# M.2 Interoperability Warning

## Executive Summary

Figure 1: M.2 (Left) and NGSFF (Right) Pin Assignments with Differences Circled

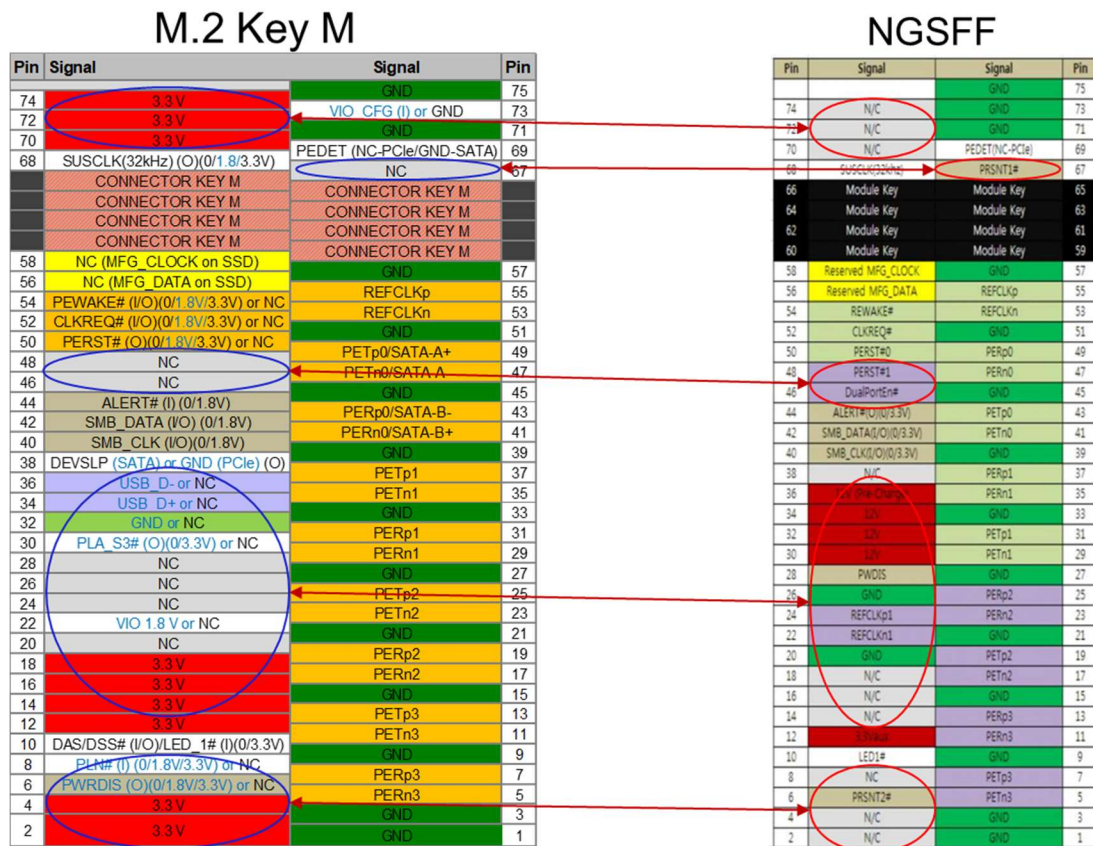
- Potential M.2 host damage due to high current placed on M.2 host CMOS output - Pin 6 of M.2, PWRDIS, will connect to NGSFF PRSNT2#
- Potential M.2 host damage due to 3.3 V on M.2 host shorting to adjacent NGSFF Add-in Card Ground (pin 18 to pin 20).
- Potential M.2 Add-in Card and NGSFF host damage from shorting 12 V to Ground - Pin 32, M.2 Ground, will connect to NGSFF 12V.
- Potential end user impact/confusion from non-functioning devices - NGSFF Add-in Card not working in M.2 host system due to limited 3.3V on NGSFF.
- Potential NGSFF Add-in Card damage due to high current placed by M.2 host - pin 12, 3.3V power, will connect to NGSFF 3.3V Aux.
- Potential NGSFF Add-in Card damage due to out of spec voltage placed on one Add-in Card input signal - Pin 22, M.2 1.8V, connected to NGSFF REFCLKn1
- Unknown future issues due to NGSFF using 5 pins that M.2 may use in the future.

M.2 specifies pin 6 as PWRDIS (host output), and NGSFF specifies it as PRSNT2# (host input). If PRSNT2# is directly grounded on the NGSFF AIC, then the M.2 Host's PWRDIS pin will connect straight to ground. Though M.2 does not specify a maximum current, this atypical usage can result in I/O buffer electrical overstress, and potentially could cause permanent damage the M.2 host signal. Further, NGSFF specifies its PWRDIS functionality on a different pin 28, thus creating unnecessary duplication and complexity.

M.2 specifies pin 22 as a 1.8V power source (VIO 1.8 V), and NGSFF specifies it as REFCLKn1 (AIC input). If the NGSFF AIC supports PCI Express, then when an NGSFF AIC is inserted into an M.2 host, the M.2 host will drive 1.8V onto a pin that expects an absolute maximum input voltage (Vmax) of 1.15V. The increased voltage could damage the NGSFF AIC reference clock logic.

M.2 specifies that a host provide 3.3V of power across the above pins, and NGSFF specifies only 3.3Vaux on one of these pins (NGSFF specifies that a host is to provide 12V of power across a different set of pins). If an NGSFF AIC is inserted into a M.2 host and the NGSFF AIC does not draw more than the maximum M.2 pin current limit, then due to insufficient power the AIC might not power up or function correctly. If the NGSFF AIC draws more than the maximum M.2 connector pin limit, then the M.2 connector pin could be overstressed which could result in damage to the M.2 host and/or the NGSFF AIC.

M.2 specifies pin 30 as PLA-S3# (host input), pin 32 as GND, pin 34 as USB D+ (host output), and pin 36 as USB D- (host output). NGSFF specifies pins 30, 32, and 34 as 12V and pin 36 as 12V pre-charge. If an M.2 AIC is inserted into an NGSFF host, then 12V power would be connected to USB D+, USB D-, and GND. If an NGSFF host is unable to discern an M.2 AIC, then the NGSFF host and M.2 AIC could be damaged.

M.2 specifies pin 20 and pin 26 as NC, and NGSFF specifies these as GND pins. If an NGSFF AIC is inserted into a M.2 host, then NGSFF AIC pin 20 would be located next to M.2 host pin 18 (3.3V power pin). If these pins were to make contact for any reason, then the M.2 host and NGSFF AIC could be damaged. To prevent such damage, M.2 and other industry standards do not locate power and ground pins where they could make contact. Further, since pin 20 and 26 are NC pins, future M.2 specifications will make use of these pins for other purposes.

M.2 specifies pins 46, 48, and 67 as NC, and NGSFF specifies these as DualPortEn#, PERST#1 and PRSNT1#. Future M.2 specifications will make use of these pins which could result in interoperability problems or damage.
